Invitation for Bid No. 2025-052

Progress Building Roof Replacement

ADDENDUM No. 1

PROJECT:	Union County Progress Building Roof Replacement	NO.:	01
OWNER:	Union County	DATE OF ISSUANCE:	10/30/2025
		ENGINEER:	REI Engineers
		REI PROJECT NO:	R25CLT-072

XR101

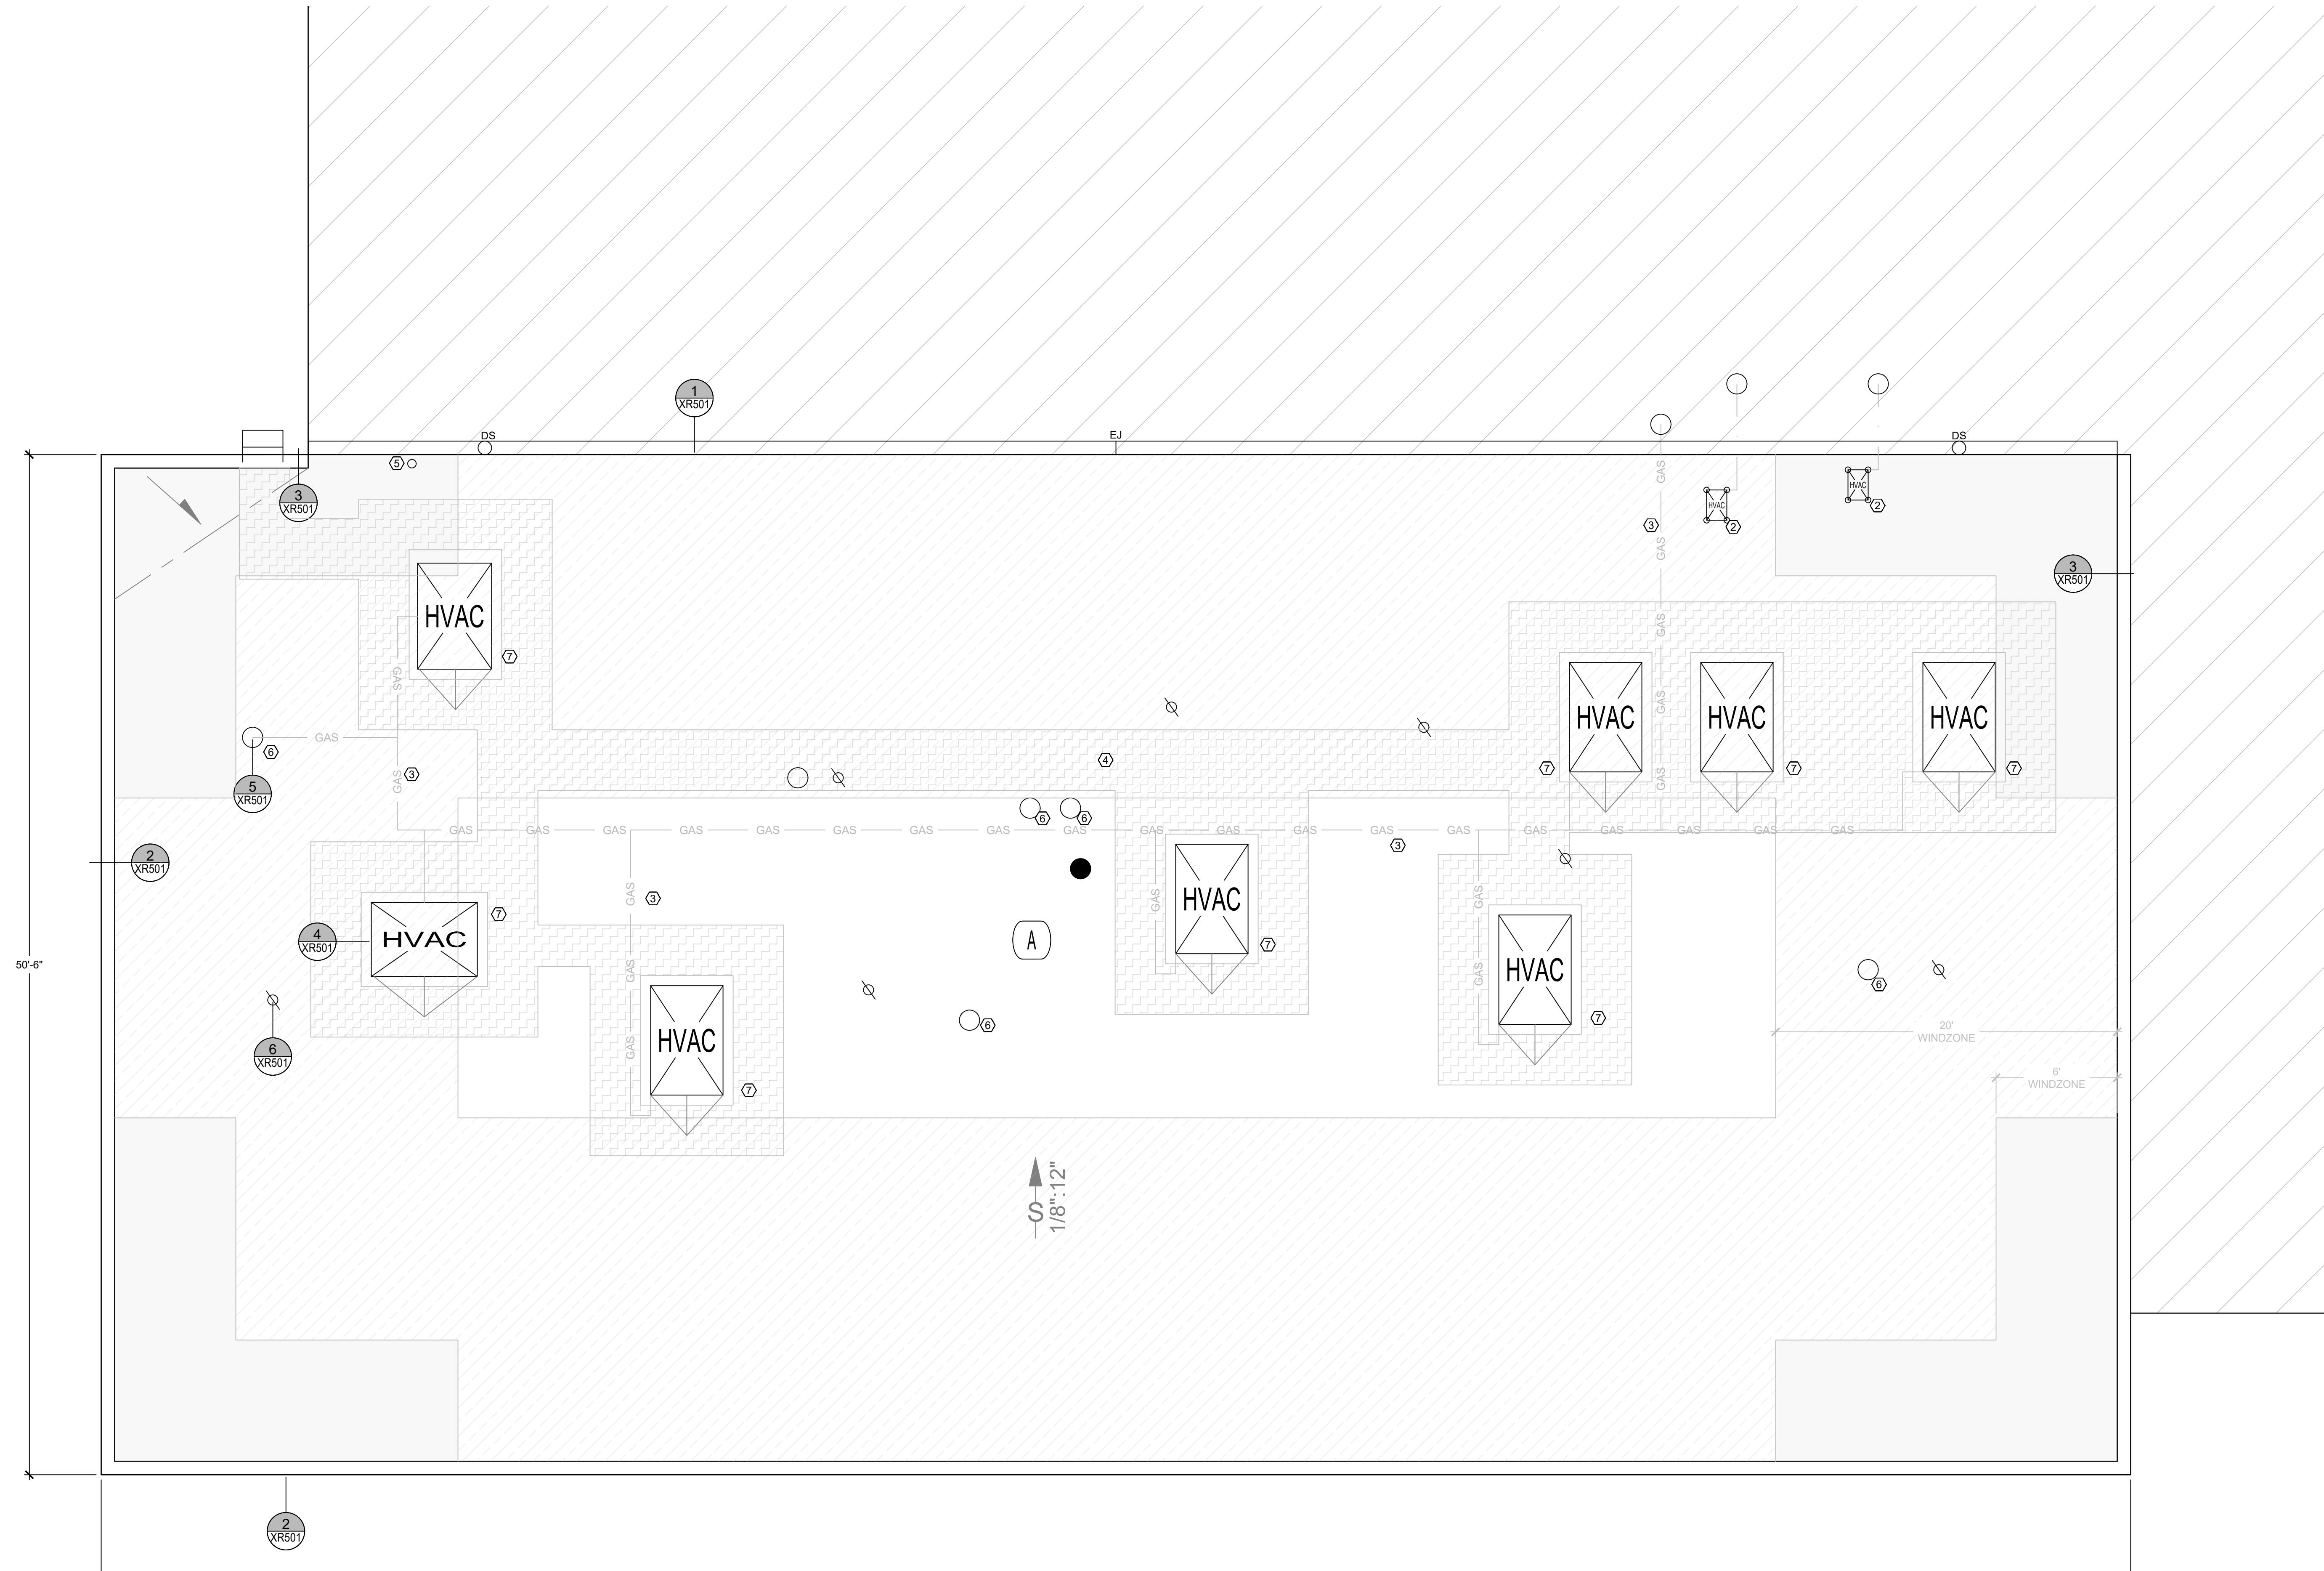
1. Drawing XR101 – Roof Plan, replace with the attached, Revision No. 1 Drawing XR101 – Roof Plan.
